SUBJECT: Removal Action Report for the 488-2D Ash Basin and 488-4D Ash Landfill (U) (SRNS-RP-2017-00057, Revision 1 Redline, September 2017) (Redline Pages Only) and Savannah River Site's Responses to the Revision 0 Document, CERCLIS Number: 63

**SRS Responses to
U.S. Environment Protection Agency**

Removal Action Report for the 488-2D Ash Basin and 488-4D Ash Landfill (U)

CERCLIS Number: 63 (SRNS-RP-2017-00057, Revision 0, March 2017)

Figure 3. D Area Project Site

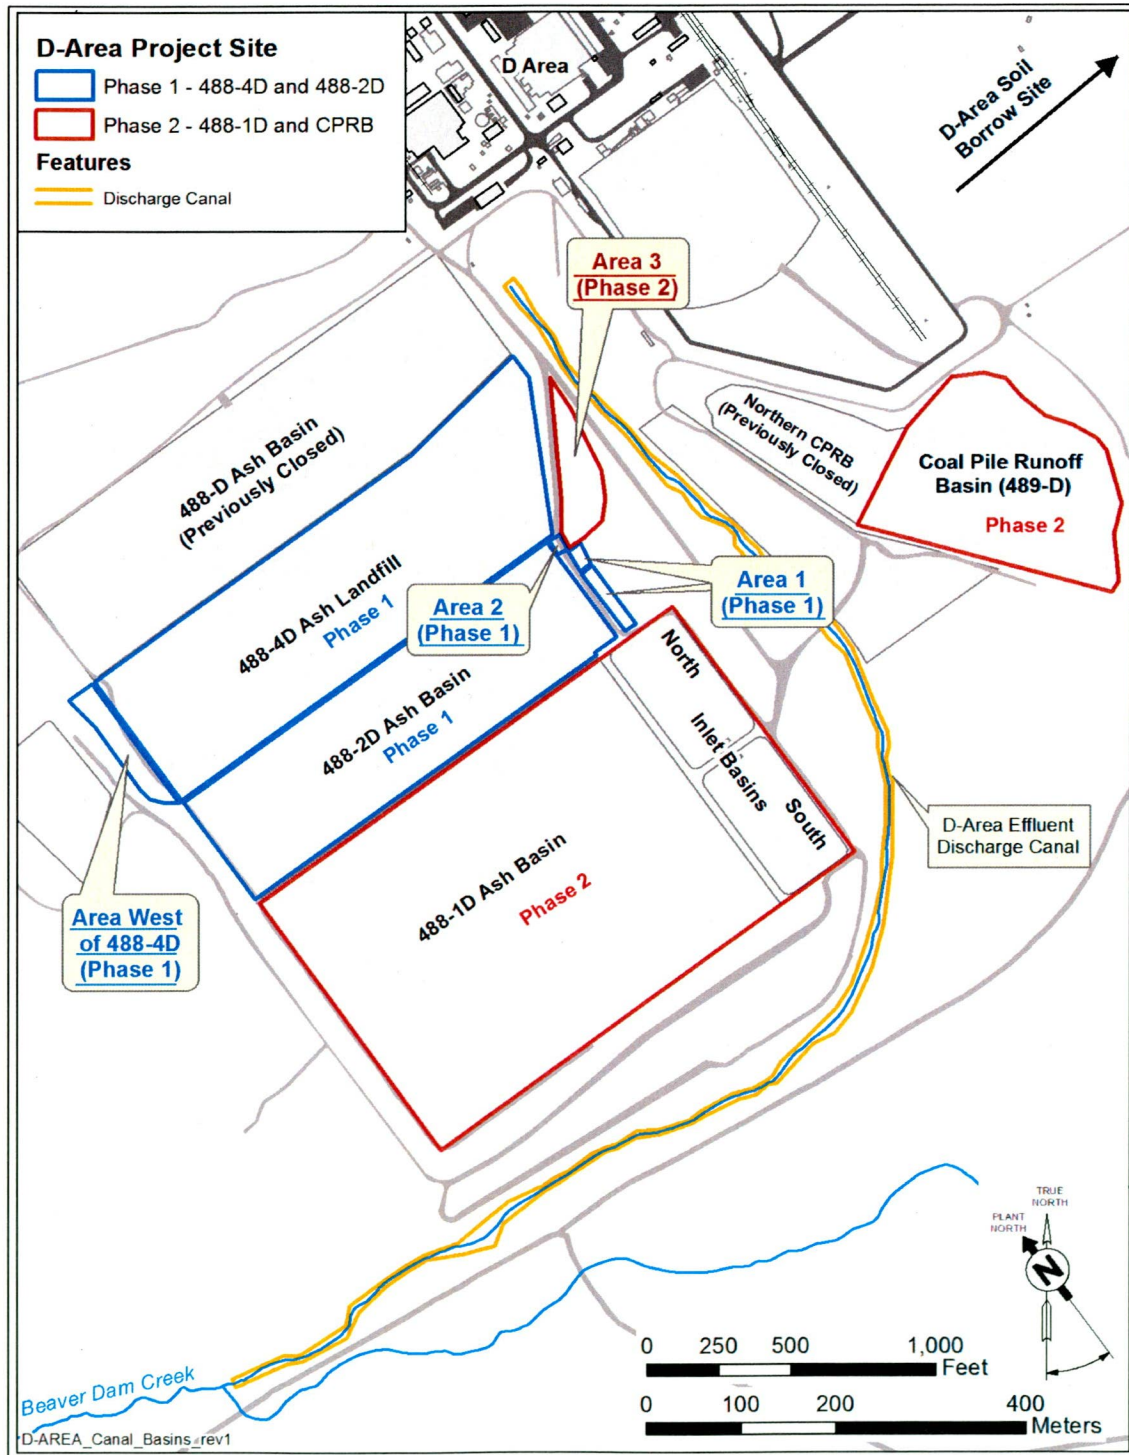
- 7) Please amend the following and all sections of the Removal Action Report to include the information pertinent to the consolidation of additional ash located outside the boundary of 488-4D/2D. This should include the requests below and any other report sections, as appropriate
- a. Section 1.2 General Description and History of the Unit, page 4, first paragraph and Figure 3, D Area Project Site, page 41.
 - b. The additional removal areas should also be shown in Figures 3 and 4.
 - c. Please include pictures, if possible, of the additional ash areas located outside the boundary of the 488-4D/2D.

of 488-2D Ash Basin and surrounding roads identified as Areas 1 and 2 on Figures 3 Figure 4 and Photos 20, 24, 35, and 51. During Phase 1 construction activities, additional ash was found east of the 488-4D Ash Landfill (Area 3) and will be removed as part of Phase 2 construction.”

Figure 3 and 4 will be revised to include Areas 1, 2, and 3 in the RAR. Additional labels will be added to photos 20, 24, 35, and 51. The revised figures and photos are provided at the end of the comment responses.

Figure 3. D Area Project Site

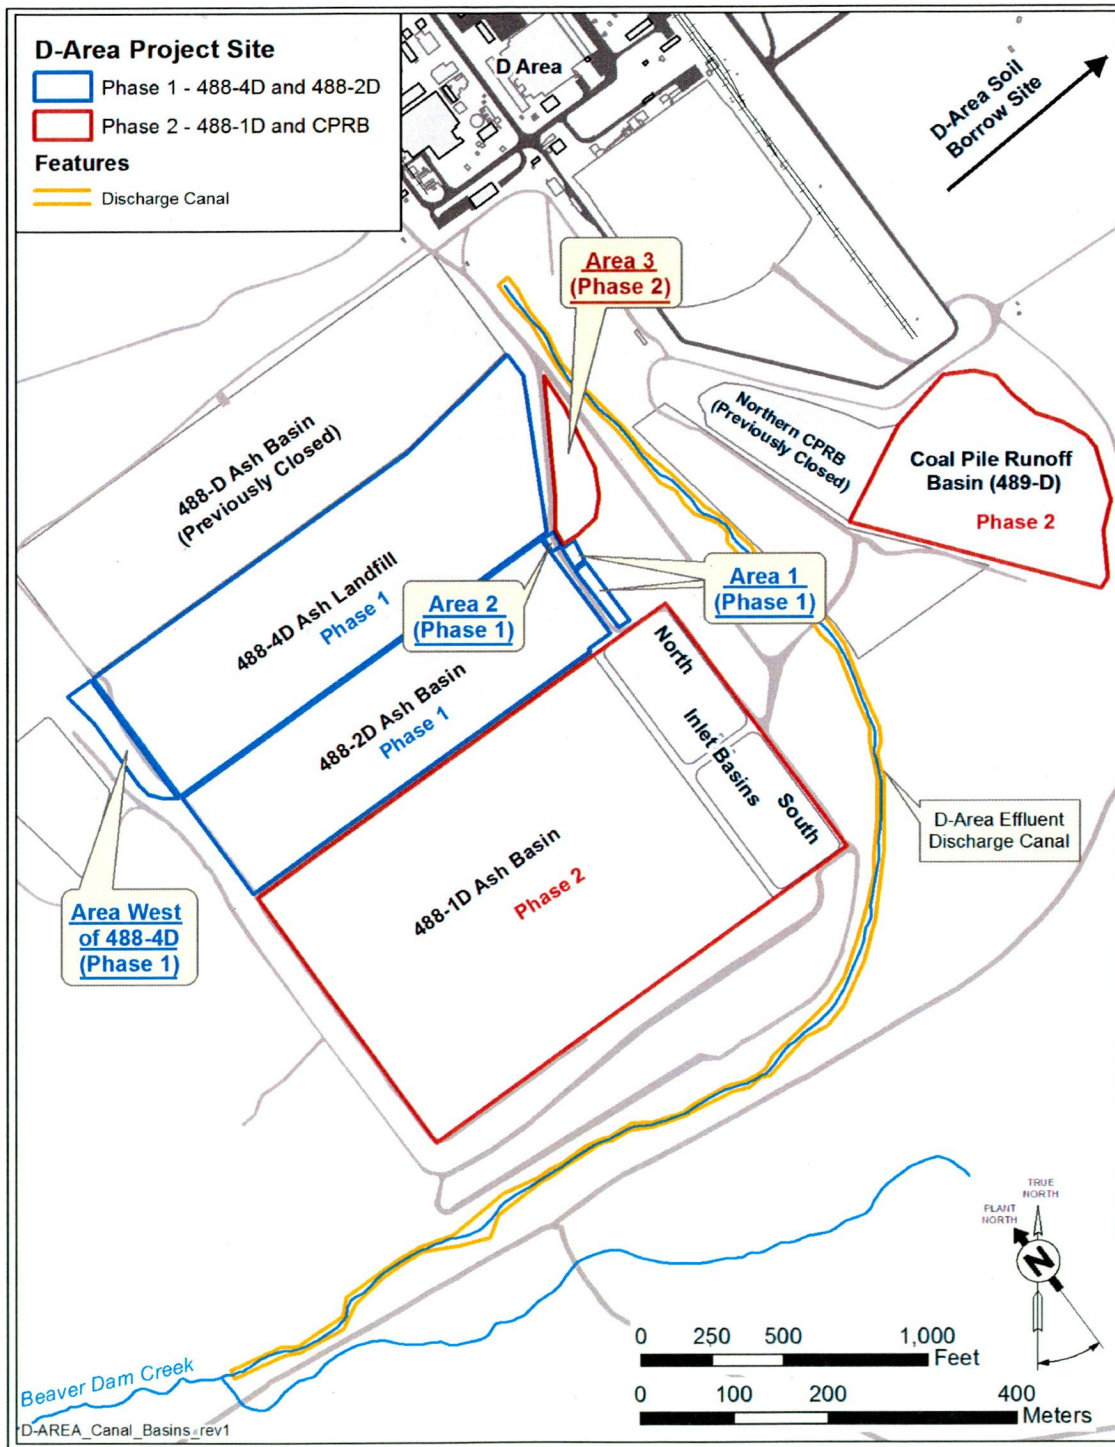
1. Section 1.2 General Description and History of the Unit, page 4, first paragraph and Figure 3, D Area Project Site, page 41. The consolidation of ash found from outside the boundary of the 488-4D Ash Landfill or 488-2D Ash Basin and placed into the 488-4D Ash Landfill should be included with the Phase I removal actions. For example, the consolidation of ash from outside the western end of the 488-4D Ash Landfill and ash from surrounding roads/berms (i.e., Area 1 and Area 2) and ash found outside of the eastern end of the 488-2D Ash Basin and 488-4D Ash Landfill (i.e., Area 3) are included with the Phase I and Phase II removal actions, respectively. Also, these additional removal areas should be shown in Figure 3.

“Additional consolidation of materials included ash and contaminated soil from outside the western end of the 488-4D Ash Landfill as well as ash from outside the eastern end of 488-2D Ash Basin and surrounding roads identified as Areas 1 and 2 on Figure 3, Figure 4 and Photos 20, 24, 35, and 51. During Phase 1 construction activities, additional ash was found east of the 488-4D Ash Landfill (Area 3) and will be removed as part of Phase 2 construction.”

Figure 3 and 4 will be revised to include Areas 1, 2, and 3 in the RAR. Additional labels will be added to photos 20, 24, 35, and 51. The revised figures and photos are provided at the end of the comment responses.
